KENWOOD

SERVICE BULLETIN

TS-930S RF FEEDBACK

7-15-83

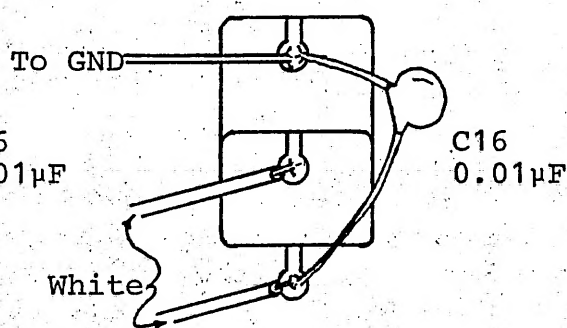
For reports of RF Feedback from the external speaker, especially when using a vertical antenna, or a linear amplifier, check for correct installation of capacitor C16 on the EXT. SPKR jack.

INCORRECT

CORRECT

Note: This bulletin is applicable to radios with serial numbers prior to # 3070420. Time required for this procedure is ½ hour or less.
